Re:- Plot No 60. M.M. 6 Machhi Miani Qr.

REVIEW FORM.

Case No. P/Q 522/36.

Reference No. B. S. P. 522/36

PLAN
SHOWING PROPOSED BUILDING ON PLOT N° 60 SHEET N° M.M.6.
MACHI MIANI QUARTER.
SCALE 8'-1"

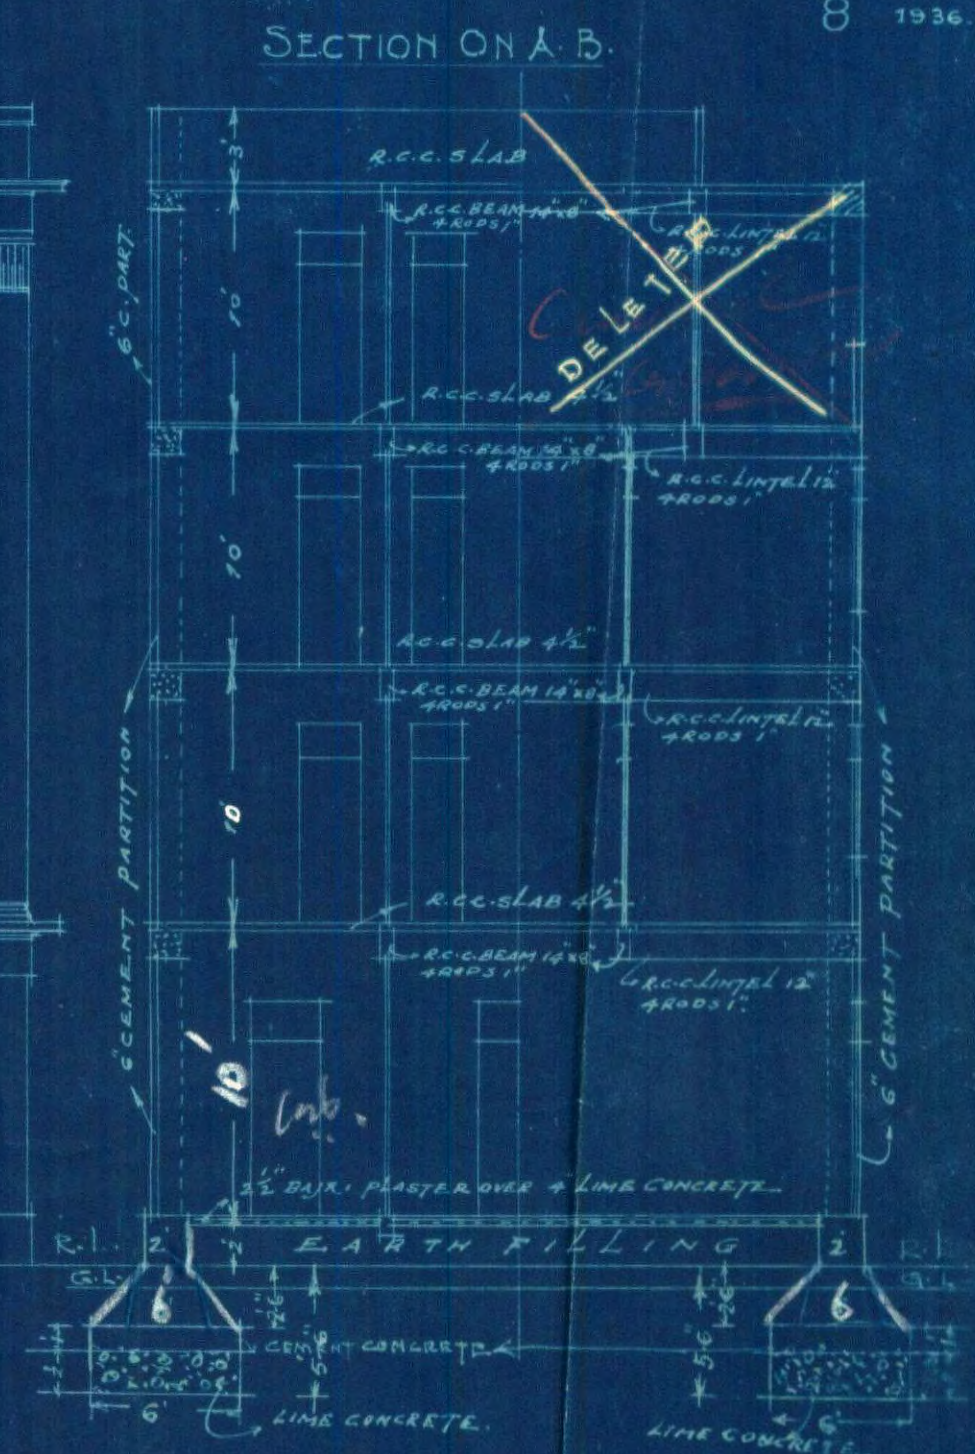
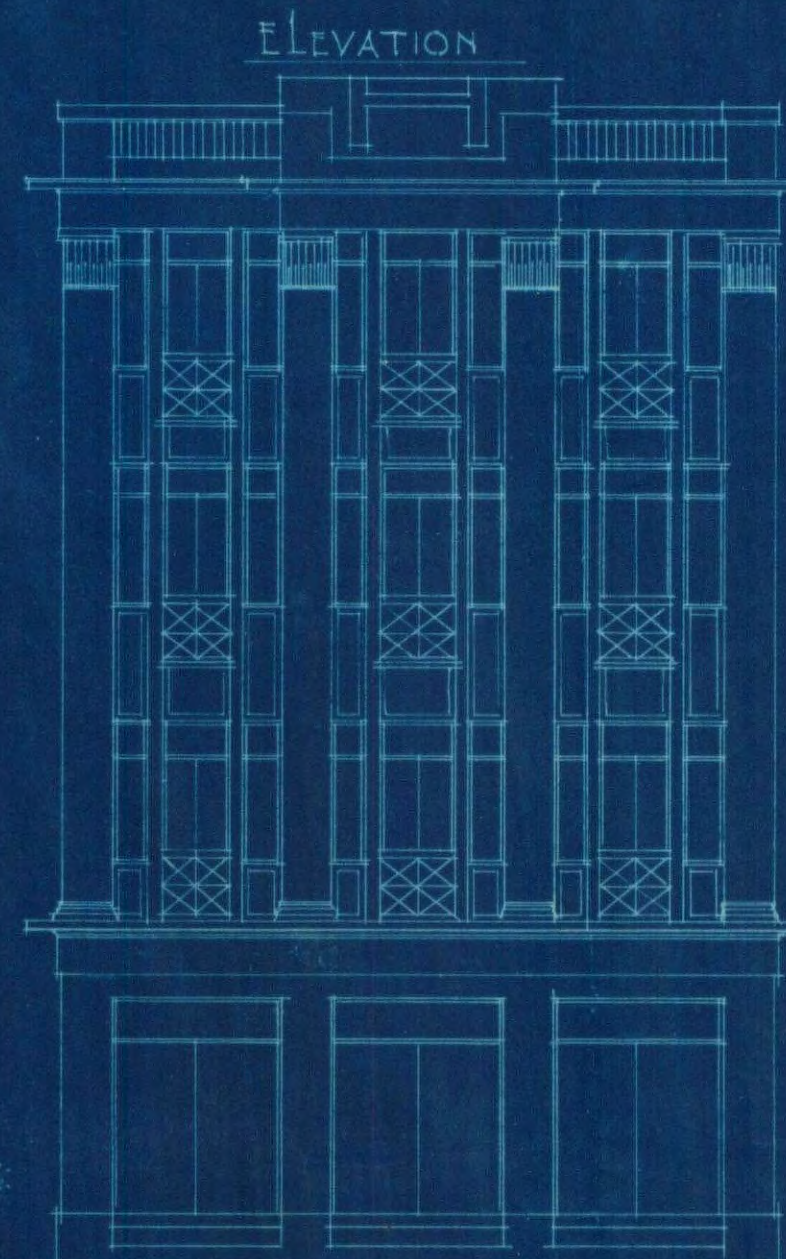
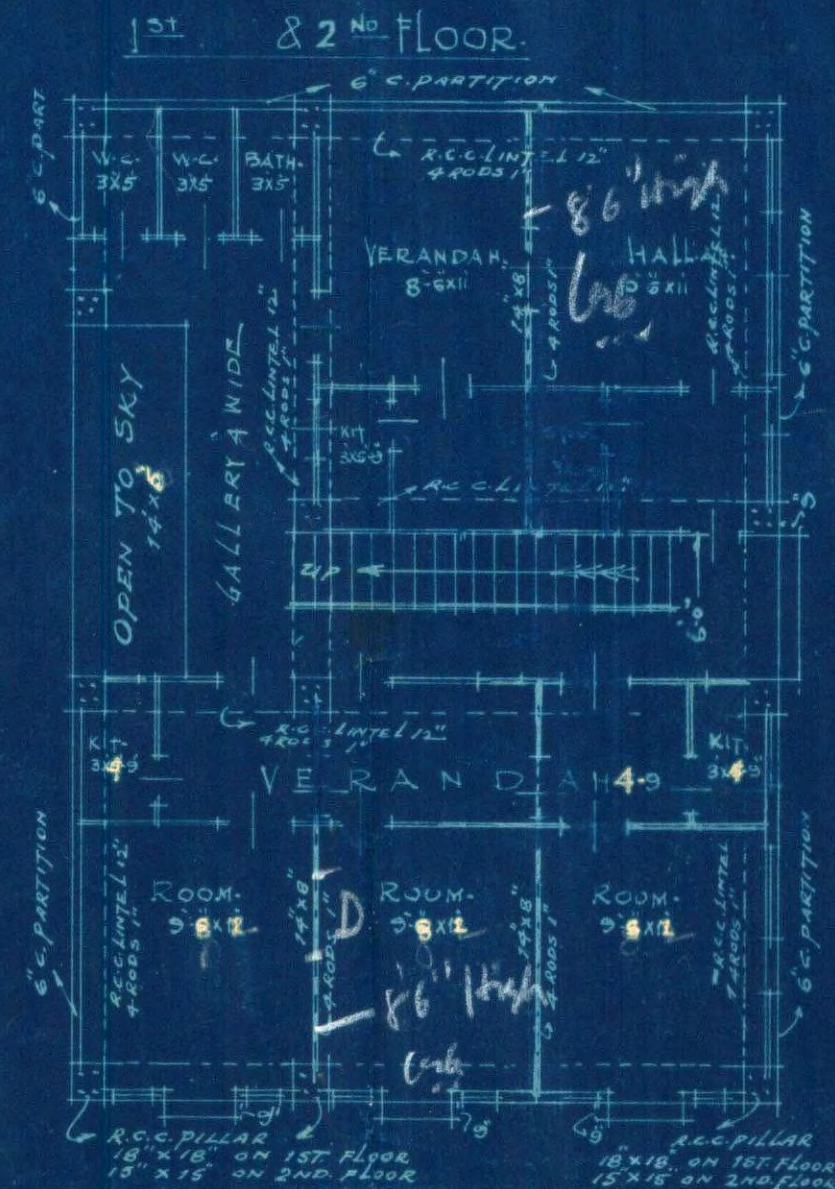
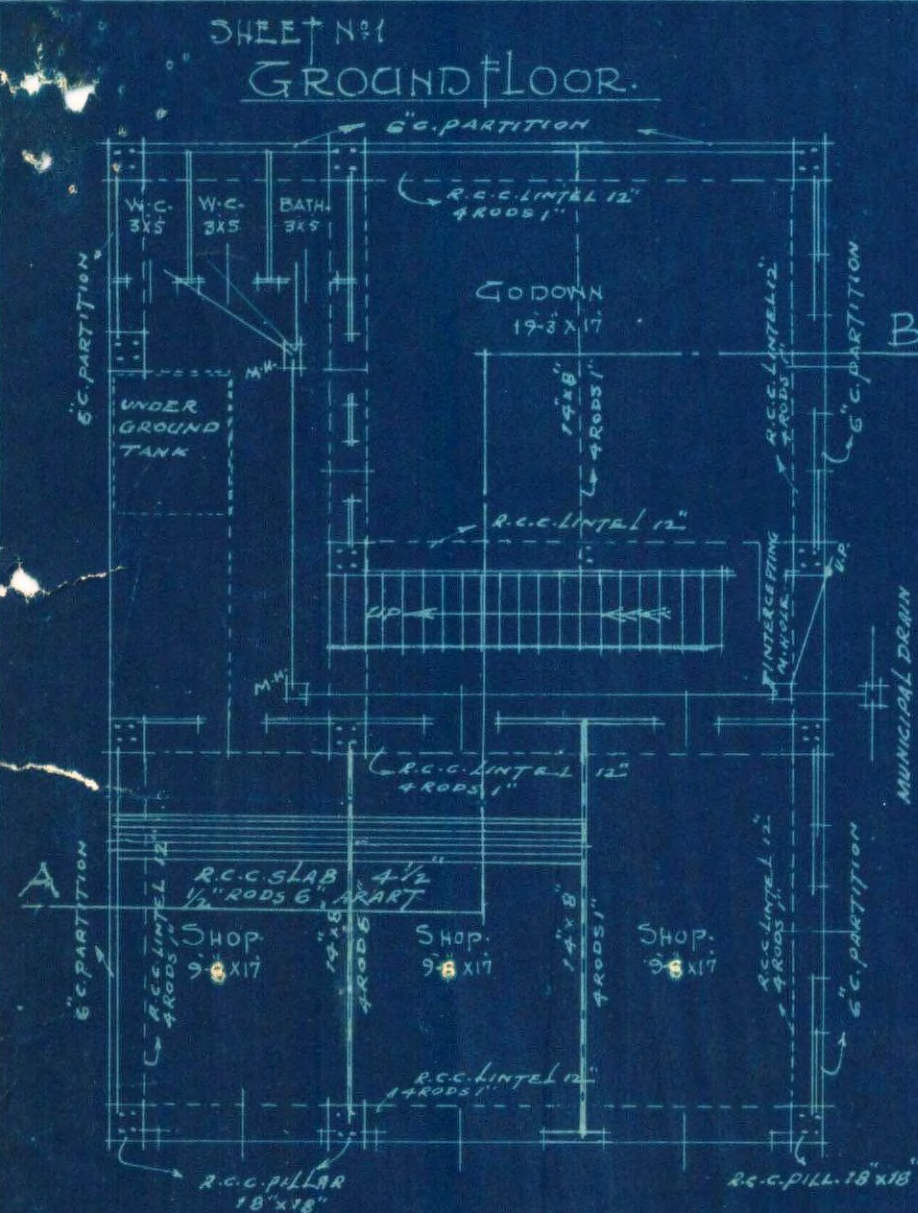
1. One room ~~treatment~~ cannot be allowed
2. The ~~is~~ called "Hall" has no sufficient open space which must be proposed.
3. The height of the building will have to be regulated in accordance with the width of the side street in so far as it relates to the rear portion
4. Foundation sections must be shown properly.
5. Size & reinforcements of R.C. beams is inadequate. They must be increased.

1. Rooms are too small.
2. Street widths must be correctly shown.
3. One room tenements cannot be allowed.
4. The so-called hall has no sufficient open space which must be proposed.
5. The height of the building will have to be regulated in accordance with the width of the side street in so far as it relates to the rear position.
6. Foundation section must be shown properly.
7. Size and reinforcement of R. C. C. beams is inadequate. They must be increased.

- 1 The room sizes have now been increased though according to the Eye Law the size of the room ought to be 100 sqt.
2. The street width has been written.
3. One room tenement has now been done away with.
4. The hall now gets light from the the street north side and is now fully ventilated.
- 5 In order to comply with this the 2nd floor plan has been recast. The out-houses are ~~22~~ 1'-6" away than required. ~~from~~ As shifting of the out houses by 1'-6" would cause dirt due to collection of water and refuse we would request you to condone the same. Similarly on the north side the street width is 16' and the height of the building is 35'. The of 6" in the street width may also kindly be condoned.
6. As for objection 6&7 the calculations are submitted to justify the correctness of the members such as beams and columns provided and shown in the drawing.

Calculation for beam.

$$A_T = \frac{4,63,500}{16 \times 100 \times 10} = \frac{46.25}{16} = 2.9 \text{ ft}^2$$

Area of reinforcement provided
is 4 bars 1" dia. which
area = 3.2 ft²

∴ The reinforcement of the
Beam is sufficient & is
not required to be
increased.
